SERVICE BULLETIN

SERVICE BULLETIN NO: 24-010

ELECTRICAL POWER - DC GENERATION REPLACEMENT OF GENERATOR 2

Replacement of the Generator 2 (P/N 524.32.12.147) with a new generator (P/N 524.32.12.158).

Relocation of the Fire Wire Connector and Sensor
Figure 1

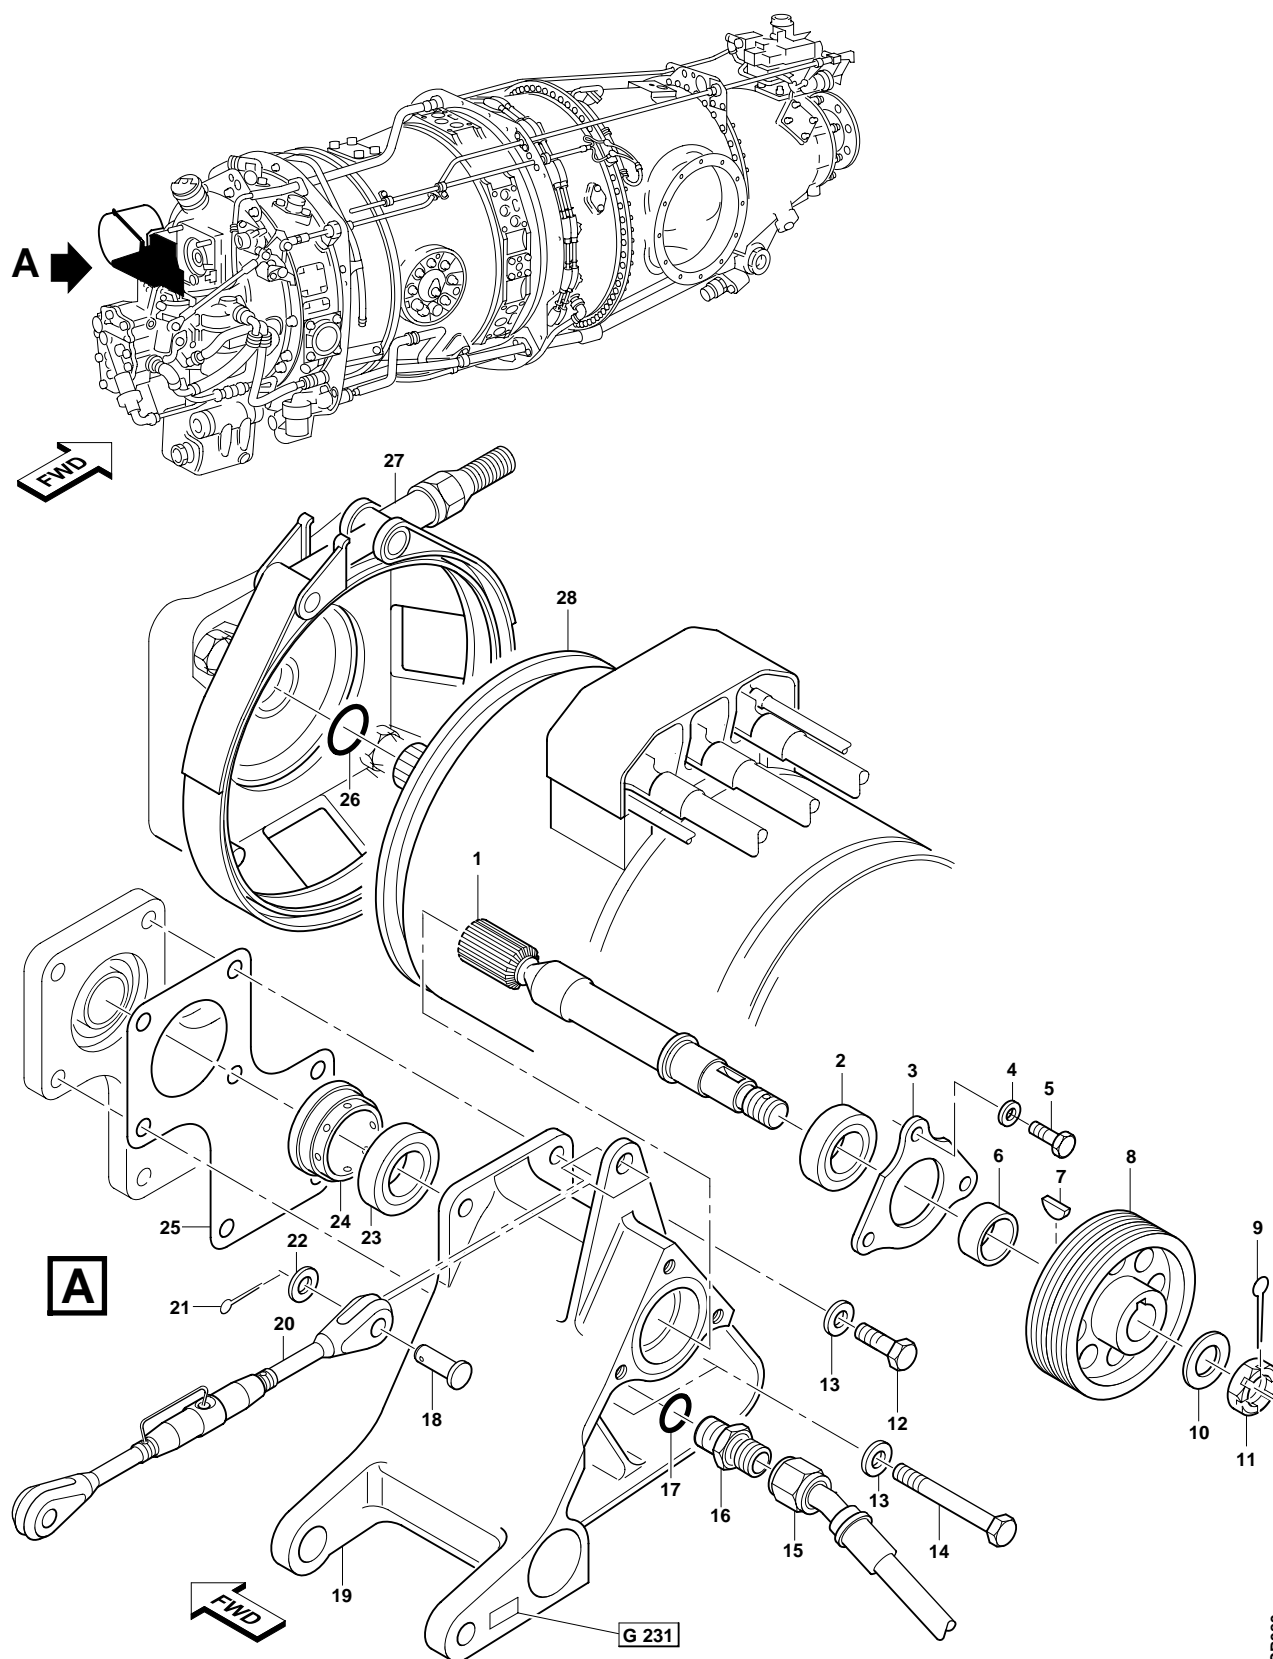
C. Fire Wire Connector and Sensor - Installation (Ref. Fig. 1)

- (1) Install the fire wire connector and sensor. This step is only applicable on aircraft with no pressure sensor (9) installed.
 - (a) Remove the nuts (12), washers (11), bolts (10), P-clamps (8), fire-wire connector (13). When you do this keep the fire-wire connector (13) in position and do not electrically disconnect it.

- (b) Remove the nuts (6) and washers (5), from the studs (2) and (3) then remove and discard the attachment bracket (7).
 - (c) Remove the nut (16) and washer (15) from the stud (4) then install them on the stud (2).

- (d) Obey the manufacturers instructions and install the placard (A571) on the support (14) at the position shown.
 - (e) Put the support (14) in position on the studs (3) & (4) and install the washers (5) and nuts (6).

- (f) Loosen the clamp (1) and pull the fire-wire through the until the fire-wire connector (13) is in the correct position. Tighten the clamp.
 - (g) Assemble the fire wire connector (13) and the P-clamps (8) on the support (14) and install the bolts (10), washers (11) and nuts (12).

- (2) Install the fire wire connector and sensor. This step is only applicable on aircraft which have the pressure sensor (9) installed (post SB 77-001).

- (a) Disassemble and (were necessary remove) the nuts (12), washers (11), bolts (10), P-clamps (8), fire-wire connector (13) and the pressure sensor (9). Hold the pressure sensor and fire-wire connector in their correct positions. Do not electrically disconnect them.

- (b) Remove the nuts (6) and washers (5) from the studs (2) and (3) then remove and discard the attachment bracket (7).
 - (c) Remove the nut (16) and washer (15) from the stud (4) and install them on the stud (2).

- (d) Obey the manufacturers instructions and install the placard (A571) on the support (14) at the position shown.
 - (e) Put the support (14) in position on the studs (3) & (4) and install the washers (5) and nuts (6).

- (f) Loosen the clamp (1) and pull the fire-wire through the until the fire-wire connector (13) is in the correct position. Tighten the clamp.
 - (g) Assemble the fire wire connector (13) pressure sensor (9) and the P-clamps (8) on the support (14) and install the bolts (10), washers (11) and nuts (12).

Installation of the New Drive Assembly
Figure 2

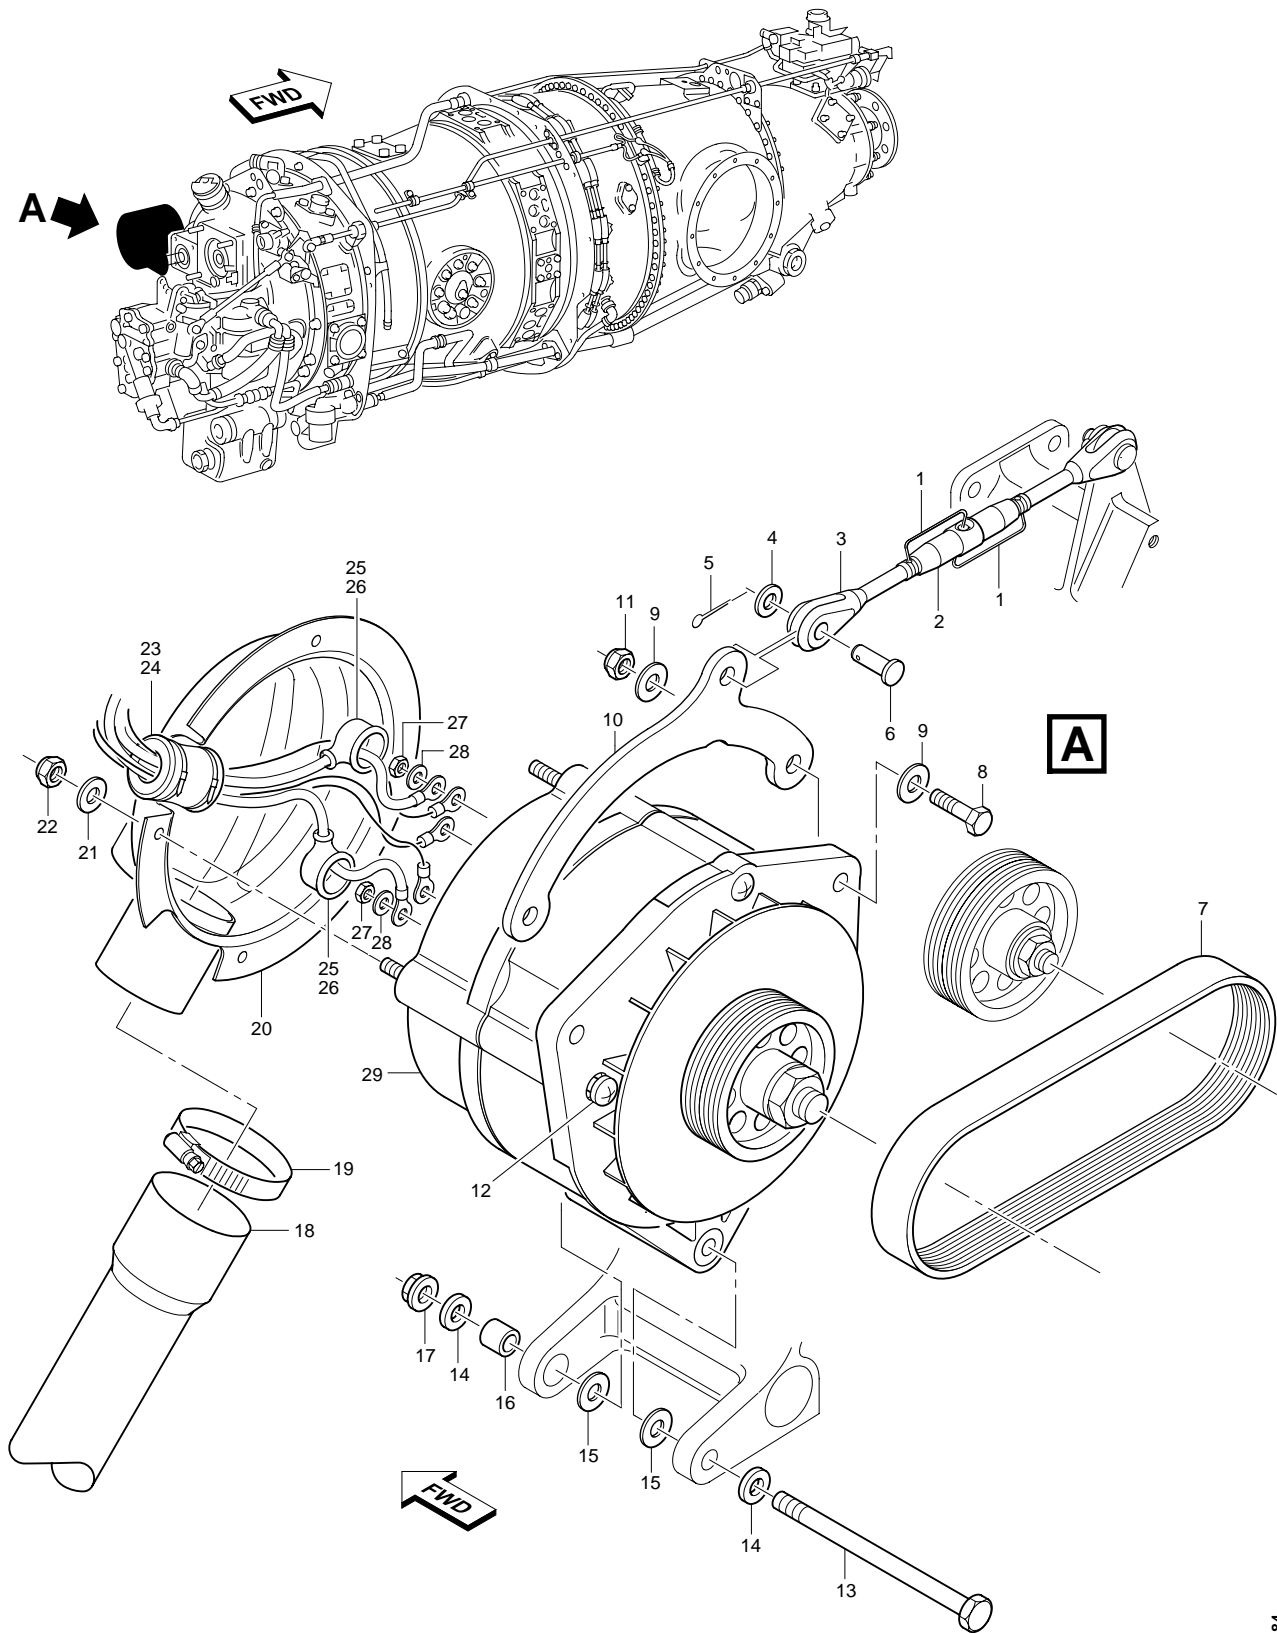
D. Drive Assembly - Modification and Installation (Ref. Fig. 2)

- (1) Examine the engine internal gearshift for damage and wear (Ref. EMM 72-60-00).
- (2) Obey the manufacturers instructions and install the placard (G231) on the new drive housing (19) at the position shown.
- (3) Obey the manufacturers instructions and apply layers of corrosion preventative (Item No. P10-005) on the applicable surfaces of the:
 - Cover (3)
 - Drive housing (19)
 - Drive shaft (1) (do not apply to splines)
 - Washers (4), (10), (13) and (22)
 - Bolts (5), (12) and (14)
 - Woodruff key (7)
 - Pulley (8) (surface of the internal bore only)
 - Centring sleeve (24)
 - Distance sleeve (6)
 - Turn-buckle (20)
 - Pin (18)
 - Nut (11)
- (4) Install the new packing (17) and union (16) in the oil drain of the drive housing (19).

- (5) Install the bearing (23), centring sleeve (24), drive shaft (1) and bearing (2) in the drive housing (19).
- (6) Put the cover (3) in position on the housing (19) and Install the washers (4) and bolts (5).

- (7) Assemble the distance sleeve (6), new Woodruff key (7), pulley (8), washer (10) and nut (11) on the drive shaft (1).
- (8) Torque the nut (11) to between 141 and 177 lbf in. (16 and 20 Nm) (Ref. AMM, 20-20-01, Page Block 1).

- (9) Safety the nut (11) it with a new cotter pin (9) (Ref. AMM, 20-20-00, Page Block 1).
- (10) Use the engine oil (Item No. P10-004) to lubricate the splines of the drive shaft (1).

- (11) Put the new gasket (25) and the drive housing (19) in position on the engine gearbox and install the washers (13) and bolts (12) and (14).
- (12) Torque the bolts (12) and (14) to between 75 and 85 lbf in. (8,5 and 9,6 Nm) (Ref. AMM, 20-20-01, Page Block 1).

- (13) Safety the bolts (12) and (14) with lock wire (Ref. AMM, 20-20-00, Page Block 1).
- (14) Connect the drain pipe (15) to the union (16).
- (15) Use the engine oil (Item No. P10-004) to lubricate the new O-ring seal (26) and the splines of the starter/generator (28).

- (16) Install the starter/generator (28) (Ref. AMM, 24-30-01, Page Block 401).
- (17) Connect the new turn-buckle (20) on the lug of the drive housing (19) with the pin (18), washer (22) and a new cotter pin (21) (Ref. AMM, 20-20-00, Page Block 1).

Installation of the New Generator 2
Figure 3

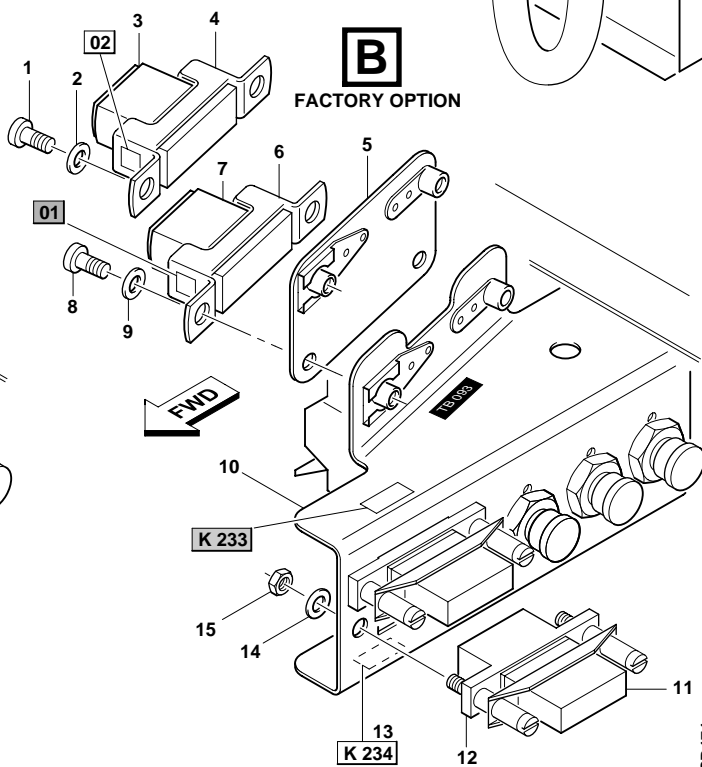
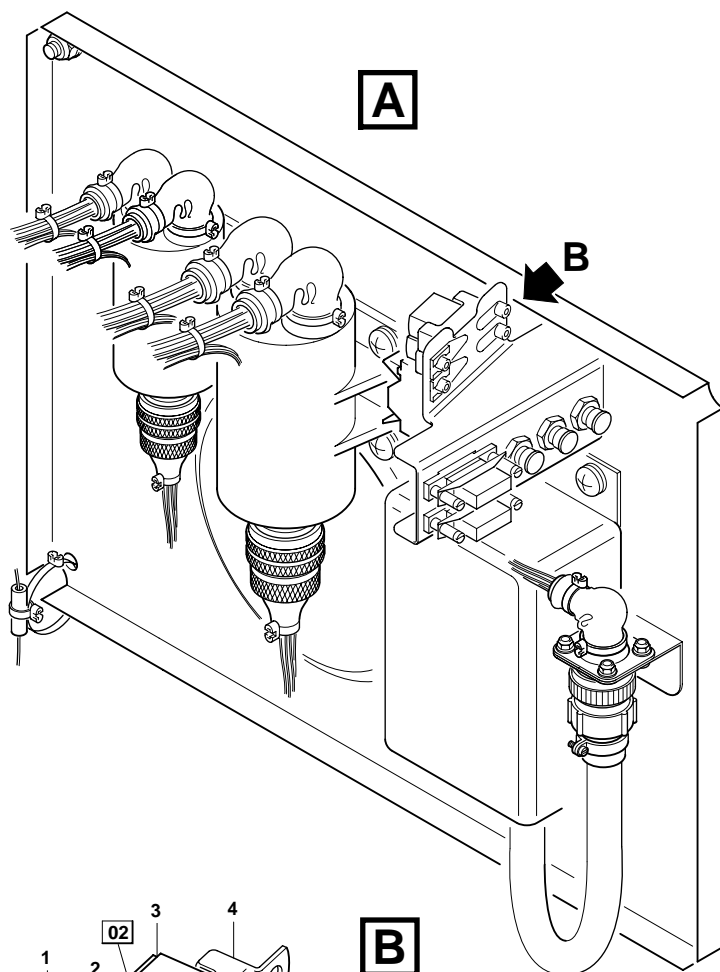
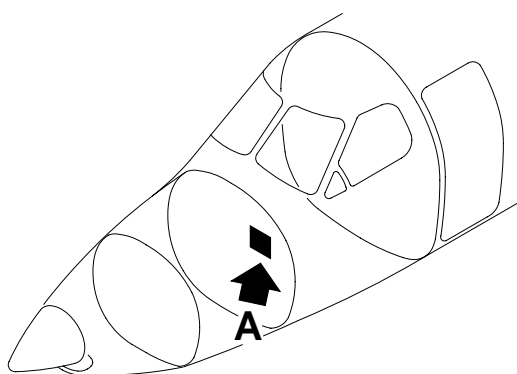
E. Generator 2 - Installation (Ref. Fig. 3)

- (1) Obey the manufacturers instructions and apply layers of corrosion preventative (Item No. P10-005) on the applicable surfaces of the:
 - Bracket (10)
 - Washers (4), (9), (14) and (15)
 - Bolts (8), (12) and (13)
 - Nut (11), (17) and (22)
 - Pin (6)
- (2) Put the bracket (10) in position on the new Generator 2 (29) and install the bolts (8), washers (9) and nuts (11).
- (3) Obey the manufacturers instructions and apply a layer of the anti-seize compound (Item No. P04-029) on the applicable surface of the sleeve (16).
- (4) Install the sleeve (16) in the lug of the drive housing. Remove the unwanted anti-seize compound.
- (5) Put the Generator 2 (29) in position and loosely install the bolt (13) and new shims (15).

- (6) Make sure the pulleys are correctly aligned.
 - (a) Use a straight edge (or equivalent tool) make sure the pulley of the Generator 2 (29) is correctly aligned with the pulley (8, Fig 2). If necessary, measure and record the distance and direction to which the pulleys are incorrectly aligned.

- (b) If the pulleys are incorrectly aligned, remove the bolt (13, Fig 3), Generator 2 (29) and shims (15).
 - (c) Add or remove the shims (15) as necessary to adjust the position of the Generator 2 (29) in relation to the values recorded in Step (a).

- (d) Put the Generator 2 (29) in position and loosely install the bolt (13) and shims (15).
 - (e) Do Step (a) again to make sure the pulley of the Generator 2 (29) is correctly aligned with the pulley (8, Fig 2). Do Steps (a) thru (e) as many times as necessary to align the pulleys.

- (7) Install the washers (14) and nut (17) on the bolt (13).
- (8) Install the new drive belt.
 - (a) Put the drive belt (7) in position on the pulley of the Generator 2 (29) and the pulley (8, Fig 2).

- (b) Put the turnbuckle fork end (3, Fig 3) in position on the bracket (10) and install the new pin (6), washer (4) and cotter pin (5).
 - (c) Adjust drive belt (7) (Ref. AMM, 24-30-03, Page Block 503).

- (9) Torque the nut (17) to between 44 and 70 lbf in. (5 and 8 Nm) (Ref. AMM, 20-20-01, Page Block 1).

- (3) Re-install the overhead EPM panel with the four screws (1).
- (4) Install the rear cover on the new Generator 2 (Ref. Fig. 3):
 - (a) Fully install the rubber boots (25) and (26) over the electrical connections at the rear of the new Generator 2 (29) with cable ties.

- (b) Install the protection (23) and (24) around the electrical cables with cable ties.
 - (c) Install the new cover (20) on the new Generator 2 (29) with the new screws (12), washers (21) and nuts (22).

Modification of the Electrical Panel Assembly in the Engine Compartment
Figure 4

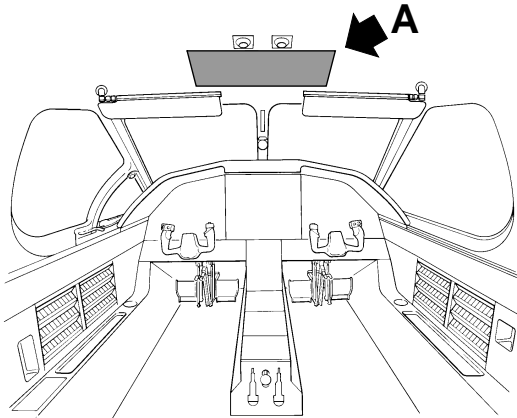
G. Terminal Block and Relay - Installation (Ref. Fig. 4)

- (1) Install the new terminal block. This Step is only applicable on aircraft with the Generator 2 Cut-out relay installed as a factory option.
 - (a) Remove the screws (8) and the washers (9), terminal block (TB093/01) (7) and support (6). Do not electrically disconnect the terminal block.

- (b) Assemble the terminal block (TB093/01) (7), support (6) and the new attachment bracket (5). Put the assembly in position and install the screws (8) and washers (9).

- (c) Assemble the new diode module TB093-02 (3), attachment bracket (5) and new support (4). Put the assembly in position and install the screws (1) and washers (2).

- (d) Obey the manufacturers instructions and install the placard (02) on the support (4) at the position shown.
- (2) Install the new relay assembly. This step is only applicable if there is no rectangular cut-out for a second relay in the bracket (10).

- (a) Remove the two nuts (15), washers (14) and the mounting (12) (together with the relay K233) from the bracket (10). It is not necessary to electrically disconnect the relay.

- (b) Make marks to show the position of the rectangular cut-out and bolt holes for the second relay on the bracket (10). You can use the mounting (12) as a template. The marks must show the second rectangular cut-out and bolt holes to be:

- Vertically aligned below, and parallel to, the cut-out and bolt holes for relay K233
 - The same dimensions as the cut-out and bolt holes for relay K233

- Make sure the mark for the top edge of the cut-out is 0.2 in. (5,0 mm) below the bottom edge of the cut-out for relay K233.
- (c) Cut and drill as necessary, the second rectangular cut-out and bolt holes in the bracket (10). Make sure there are no sharp edges.

- (d) Obey the manufacturers instructions and apply a layer of the corrosion preventative (Item No. P07-001) on the applicable edges of the second rectangular cut-out and bolt holes.

- (e) Put the mounting (12) (together with the relay K233) in position in the top cut-out of the bracket (10) and install the washers (14) and nuts (15).

- (f) Assemble the relay K234 and new mounting (12).
- (g) Put the mounting (12) and relay assembly in position in the bottom cut-out of the bracket (10) and install the new washers (14) and nuts (15).

- (h) Obey the manufacturers instructions and install the placard (K234) on the bracket (10) at the position shown.
- (3) Install the new diode module and relay assembly. This step is only applicable on post SB 24-009 aircraft.

- (a) Assemble the diode module TB093-02 (3) and new support (4).
- (b) Put the support (4) and diode assembly in position on the bracket (16) and install the new washers (2) and screws (1).

- (c) Obey the manufacturers instructions and install the placard (02) on the support (4) at the position shown.
- (d) Assemble the relay K234 and new mounting (12).

- (e) Put the mounting (12) and relay assembly in position in the bottom cut-out of the bracket (16) and install the new washers (14) and nuts (15).
- (f) Obey the manufacturers instructions and install the placard (K234) on the bracket (16) at the position shown.

Overhead Panel
Figure 5

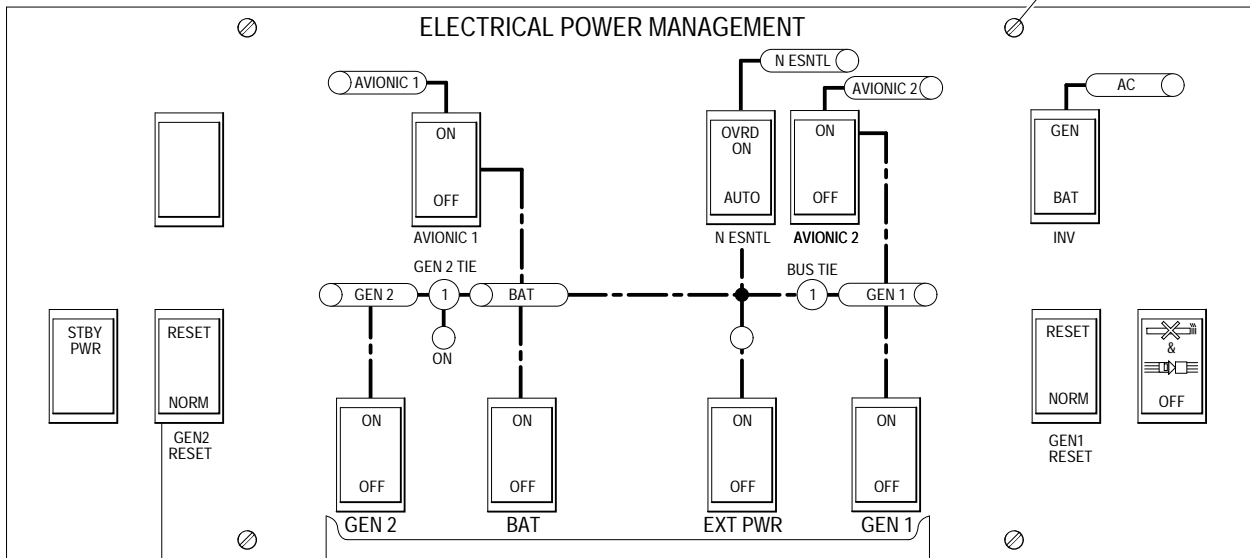
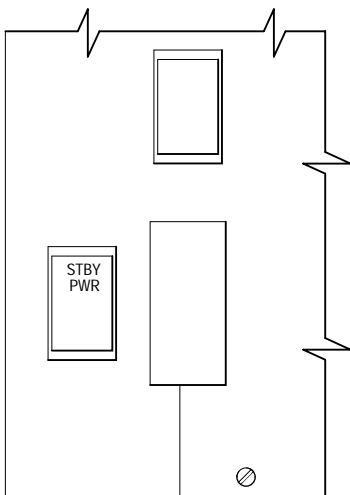
- (1) Remove the four screws (1) and overhead EPM panel (2) (Ref. Fig. 5).
- (2) Disconnect, and where necessary, remove the wires (Ref. Table, Wire/Cable - Removal and Fig. 6).

- (2) Remove and discard the GEN 2 RESET switch S232 from the overhead EPM panel (2). Install the new blanking plate and special washers (4 and 5) to cover the hole.
